## INTERCHANGEABILITY OF INPUT SHAFTS

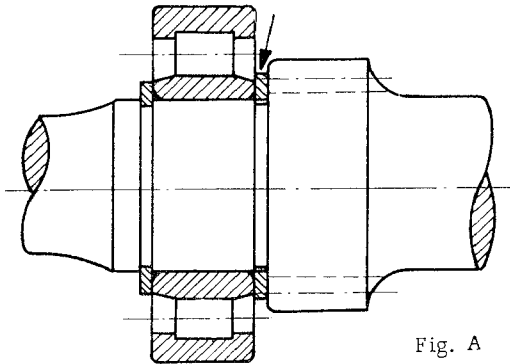
Fig. A illustrates the standard location of an intermediate ring between gear 1 for the 1st speed on the input shaft 741.302.101.10 and the roller bearing, from transmission No. 51017.

The intermediate ring has spare part No. 741.302.296.00.

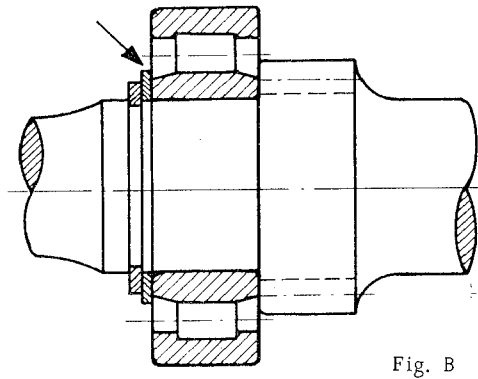
Fig. B illustrates the location of the intermediate ring when installed with input shaft 741.302.101.10 in a transmission housing 644.20.010 or 716.301.010 or 741.301.010.00.

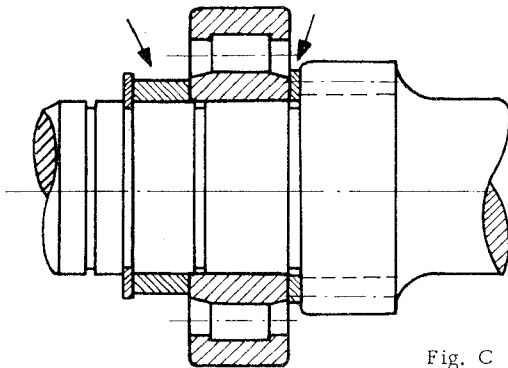
Fig. C illustrates the location of the intermediate ring and distance ring, when installed with input shaft 519.20.249 in a transmission housing 741.301.010.10.

The distance ring has spare part No. 644.20.209.
